NUMBER: 08-037-18

Engine Harness Rubbing on Intermediate Shaft

This bulletin involves installing a nylon zip tie to secure the engine harness.

2018 (WK) Jeep Grand Cherokee

Fig. 3
Location of New Nylon Zip Tie

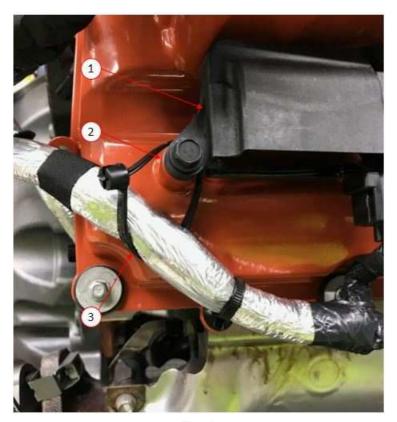
6. Secure the engine harness to ignition coil number eight boss, on the valve cover. Ensure the harness is routed over the corner of valve cover, as shown in (Fig. 3).

- 1 Number 8 Ignition Coil
- 2 Ignition Coil Boss
- 3 Nylon Zip Tie
- 7. Confirm there is 10mm (.39 inch) of clearance between the intermediate shaft and the engine wire harness.
- 8. Cut off any excess nylon zip tie.
- 9. Install coolant recovery bottle.
- 10. Install the coolant vent hose barrel clip, on the stud of the shock tower.
- 11. Install the two coolant recovery bottle bolts.
- 12. Install wire harness retaining clip on to the coolant recovery bottle.
